RE: HUMBER RIVER BRIDGE AT BOLTON  
HIGHWAY NO. 50, DISTRICT NO. 6  
WP35-60.

Re: Sheet Piling  
Humber River Bridge at Bolton  
WP 35-60

Re: Humber River Bridge at Bolton,  
Hwy. No. 50, District No. 6,  
W.P. 35-60.

Notes of Meeting - Humber River Bridge at Bolton - D.H.C. W.P. 35-60

DEPARTMENT OF HIGHWAYS - ONTARIO  
 MATERIALS & RESEARCH SECTION  
 COMPARISON OF SUB SOIL  
 CONDITIONS AT THREE SITES  
 IN BOLTON

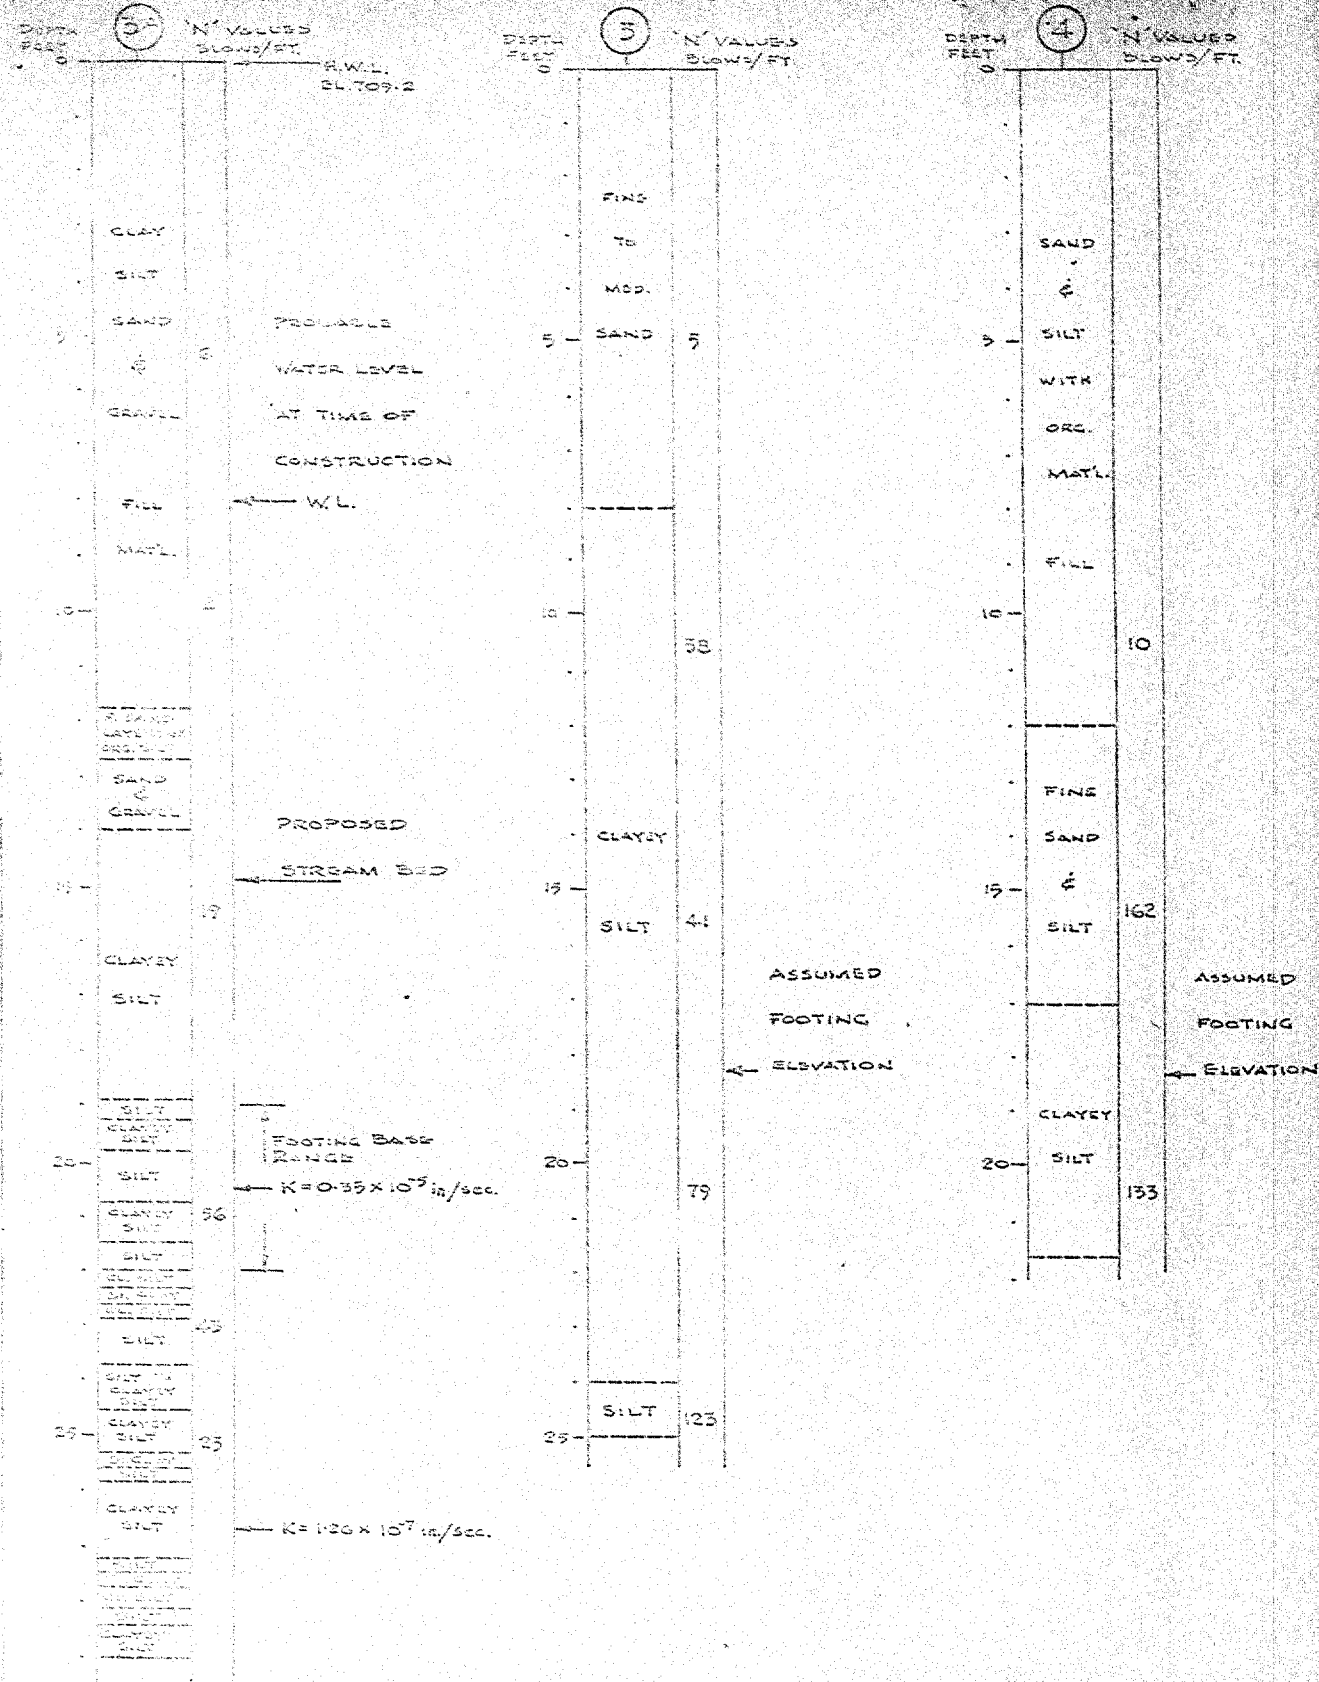
The investigation has shown that from 14.0 ft. downward, the subsoil is stratified, consisting of layers of clayey silt, silt, and silty clay. The stratification is shown on the accompanying sketch.

Comparative permeability tests have shown different coefficients of permeability for the silt material - ( $K = 3.5 \times 10^{-4}$  in/sec) and the clayey silt material - ( $K = 1.26 \times 10^{-7}$  in/sec). These values cannot be taken as absolute, but rather as indications of permeability differences.

Two boreholes were also drilled, one at each of the two bridges located on King Street's crossings of the Humber River. These structures were built on spread footings, supposedly some 6 ft. below river bottom and during construction, neither dewatering difficulties nor piping were encountered. If the soil conditions at these sites were found to be comparable with those at the site of the proposed structure on Hwy. 50, the extrapolation of experience would be justified. However, the soil conditions were not found to be comparable, the subsoil here, being clayey silt of very to extremely high density, 'N' values being in a range of 40 to 160 blows/ft.

The above-mentioned facts and newly-gathered evidence point to the choice of sheet piling as incorporated in the design as a good and safe engineering solution. However, the stratified character of the subsoil, the difference in permeability of different layers are valid evidence that no homogeneity exists and therefore, deviations from ideal conditions for piping exist. It is practically impossible to incorporate these factors into any kind of computation or analyses, and only field trial sections could provide a reliable and true answer.

It is therefore our recommendation that work at the bridge site be started without steel sheeting and this be used only if field evidence proves it necessary. It is recommended that first the new river bed at the bridge site be excavated to its final elevation. If this is done while the water in the river is controlled and kept as low as possible (which, we understand, is possible), dewatering of the excavation is not expected to present any difficulty. After this stage is completed, excavation with simple dewatering of one of the wing walls should be commenced.

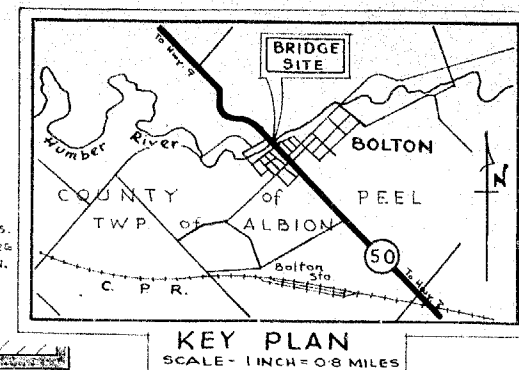
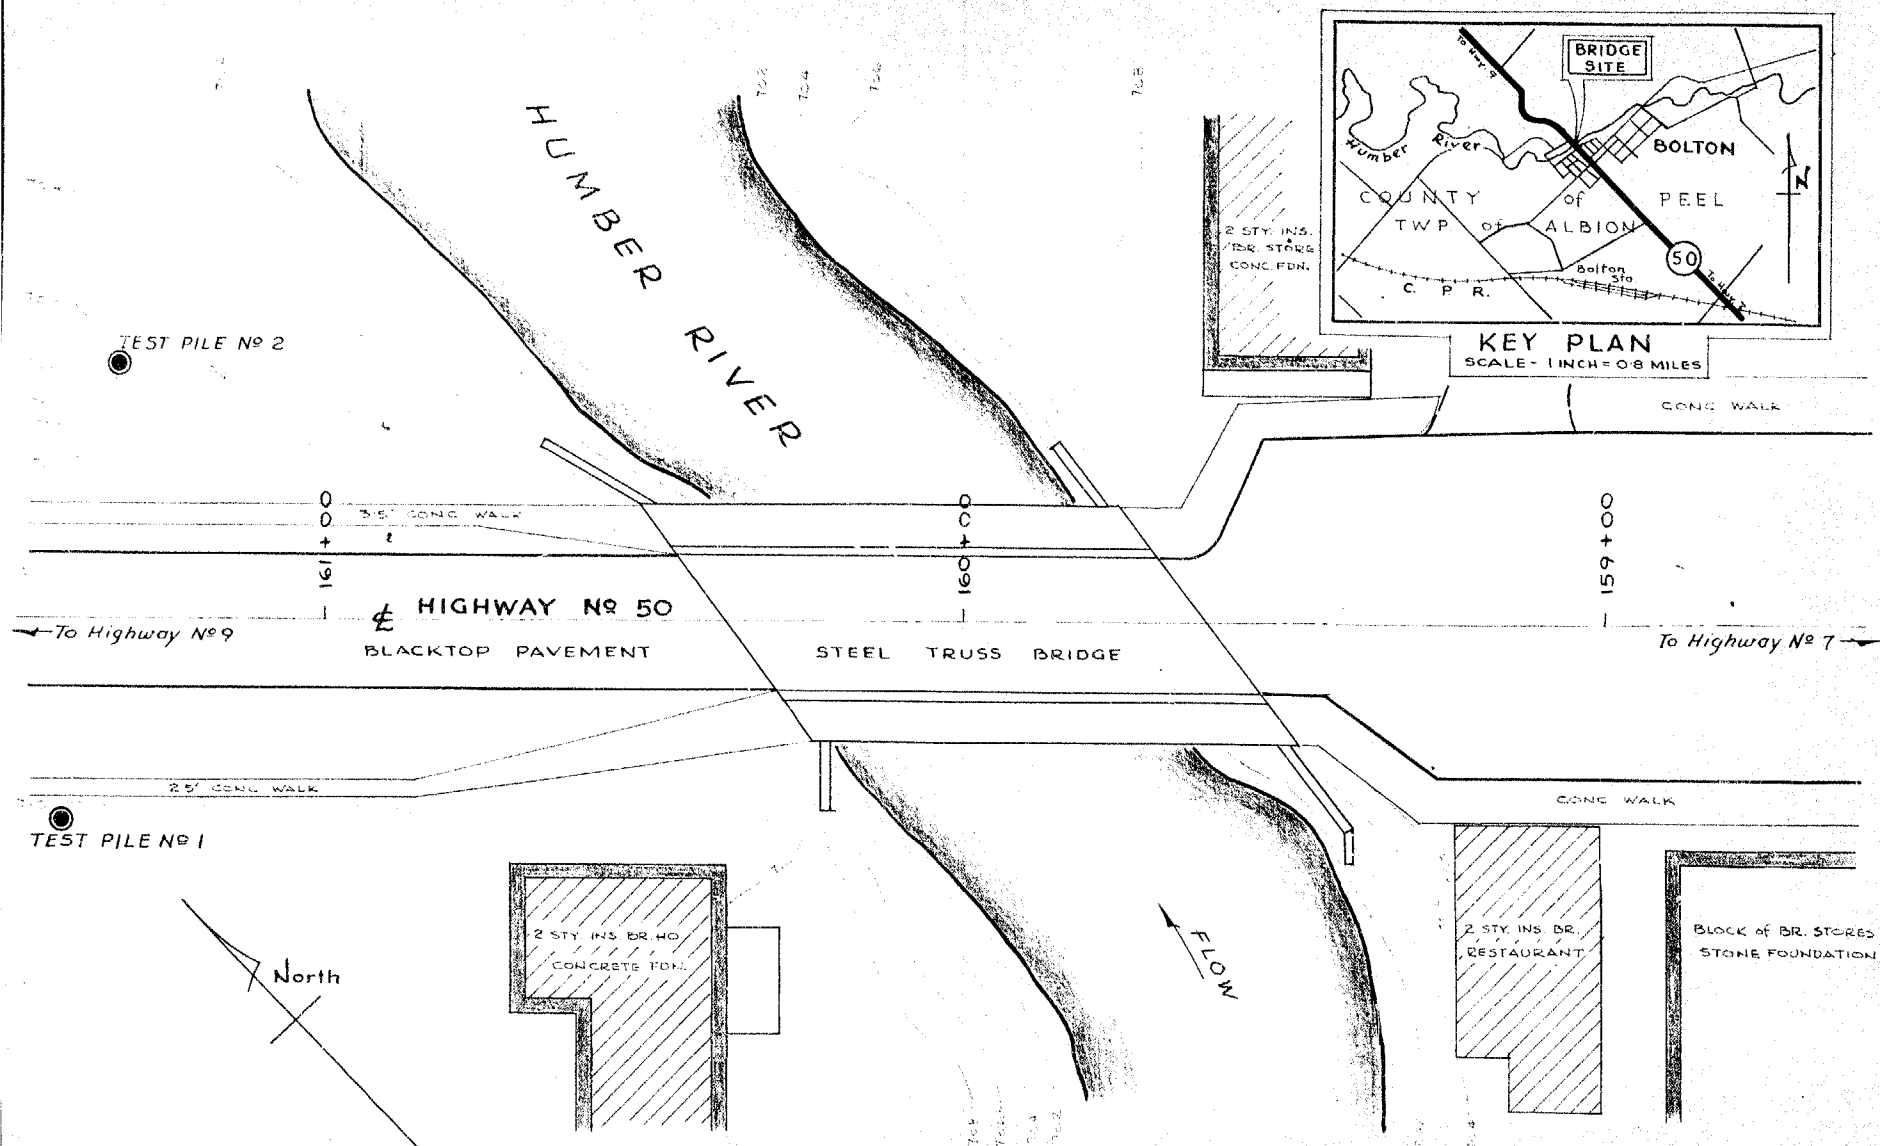
This finding has resulted in a detailed review of the proposed footing design and the following problems appear to us to make this design impracticable:-

(1) The elevation of the underside of the proposed pile cap is in the order of 6 to 8 feet below the proposed bed of the River Diversion and some 12 to 13 feet below normal river level - (which can be assumed to be ground water level). Due to the fine-grained soil type, a stable footing excavation in the dry to the depth required, cannot be guaranteed. Theoretically, "piping", or a "quicking" condition can be predicted. The conditions contributing to piping will be further augmented by the driving of displacement type piles into the soil below the footing elevation.

In view of the foregoing comments, it is our opinion that the footing design should be revised. The obvious alternative appears to be to drive interlocking steel sheet piling around the footing perimeter and then to remove the material from within the enclosure to footing elevation. Footings bearing directly upon the silty subsoil, can be designed using an allowable contact pressure of 3 tons/sq.ft. if the above procedure is followed. Sheet piling should penetrate to a depth of 8 to 10 feet below the footing founding elevation. The sheet piling should be left in place.

If, during excavation, quicking should develop, the enclosure can be flooded and excavation carried out under water. A tremie seal would then be required prior to dewatering.

We would appreciate if you could give consideration to the above alternative design and authorize Mr. Gregg to complete his design on this basis.
